# SERVICE BULLETIN

**Number:** SB0504

**Subject:** Adjustable Chain Mounts for 52K23X

Below is a diagram showing the new Adjustable Chain Mount assembly.

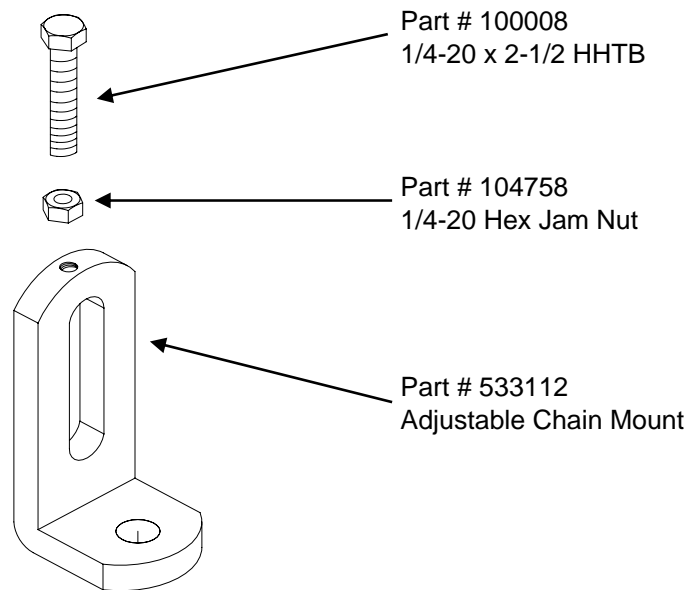
**Details:** The Deck Lift Angle, part # 423358, on the Encore X-treme 52K23X is being replaced with the Adjustable Chain Mount, part # **533112**, on units with serial # 51622 and above. The Adjustable Chain Mount will be assembled with a 1/4" bolt and a 1/4" jam nut to make the new mount adjustable.

Please note these changes in your Encore X-treme 52K23X illustrated parts manual.
